**LEAVENWORTH HIGH SCHOOL
HTK PROJ. NO. 0805.01-007**

**CONTRACT ADDENDUM NO. 6
December 11, 2009**

ADDENDUM NO 6

Leavenworth High School
2012 10th Avenue, Leavenworth, KS

AUXILIARY GYM BLEACHERS	
Project number 0805.01	AD6-A1.9
Date 24 November 2009	
Scale 1/8" = 1'-0"

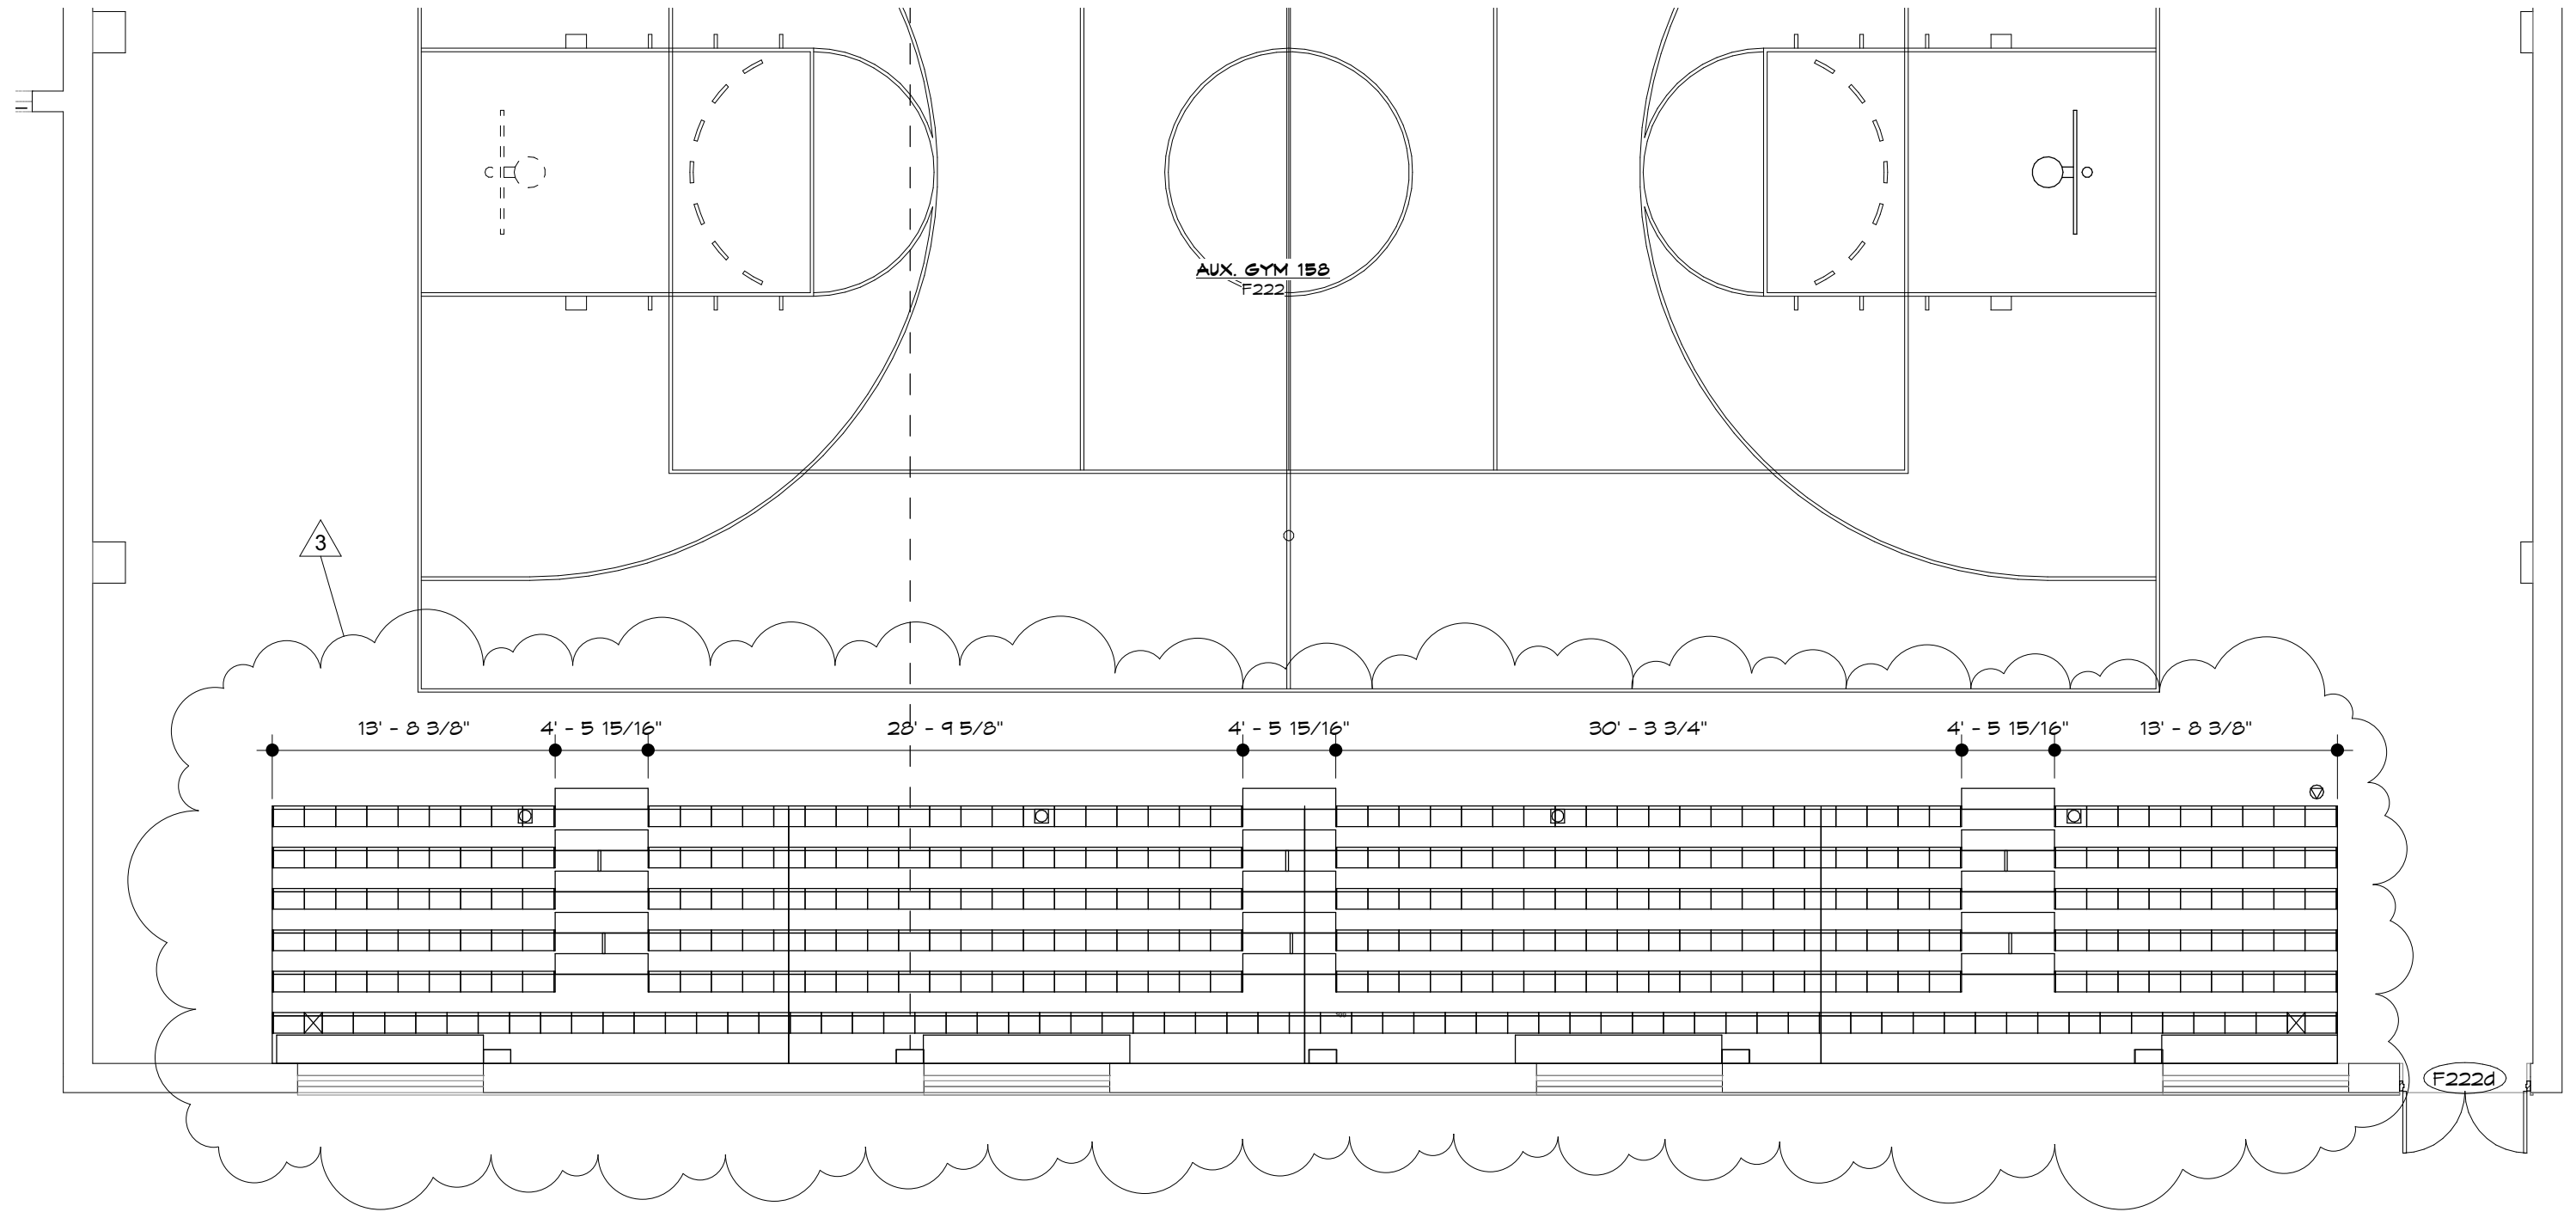
A note made reference to Drawing AD5 A1.9 that was not included in Addendum 5. Please see attached drawing AD6 A1.9 for bleacher information.

E4.3b

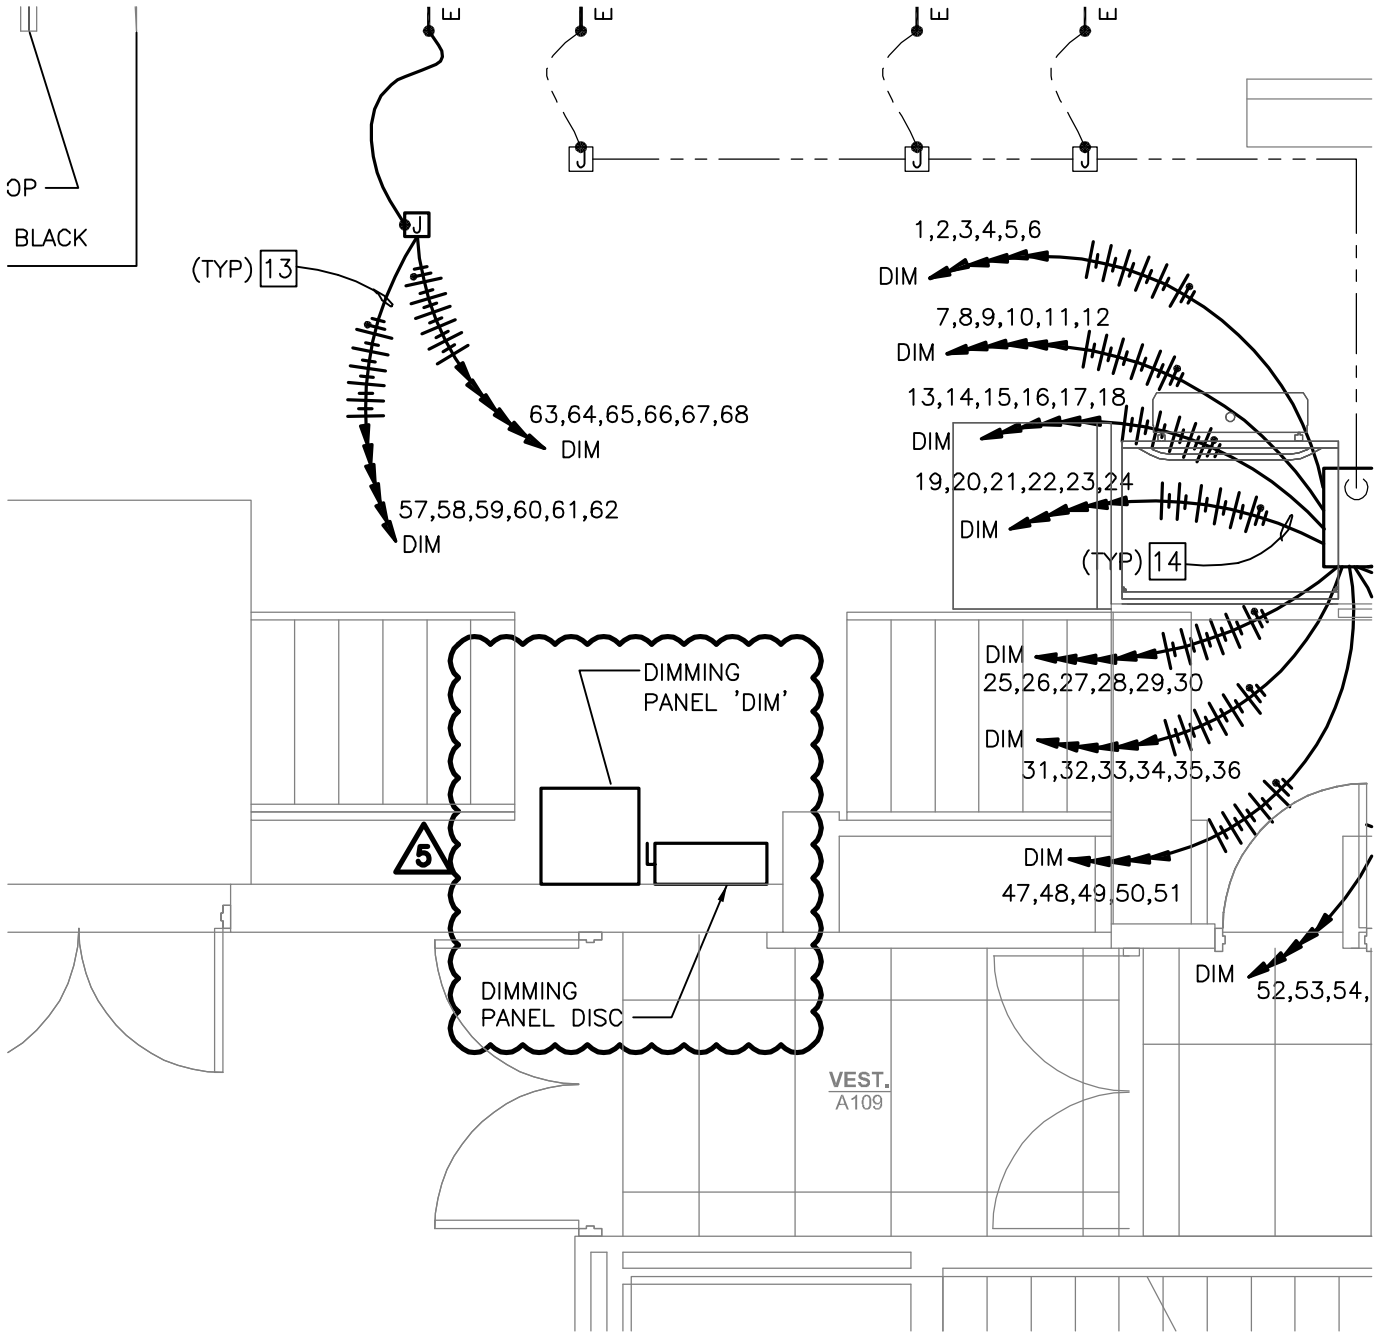
1. E4.3b
